+MEMORANDUM

DATE: April 27, 2023

SUBJECT: FMBZA Case # 20887 Application of the Kingdom of Netherlands pursuant to 11

DCMR Subtitle X § 201.8 for construction of a parking garage at its chancery.

Figure 1.

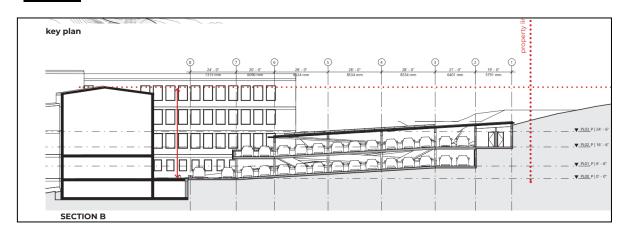
The size of the property, its topography and the location of the garage would result in no undue impact on light and air to neighboring properties. There are no buildings of the abutting properties close to the existing or proposed structure. The plans show the garage would be almost wedged into the slope where it would be located (<u>Exhibit 7 Page 21</u>) as reproduced here.
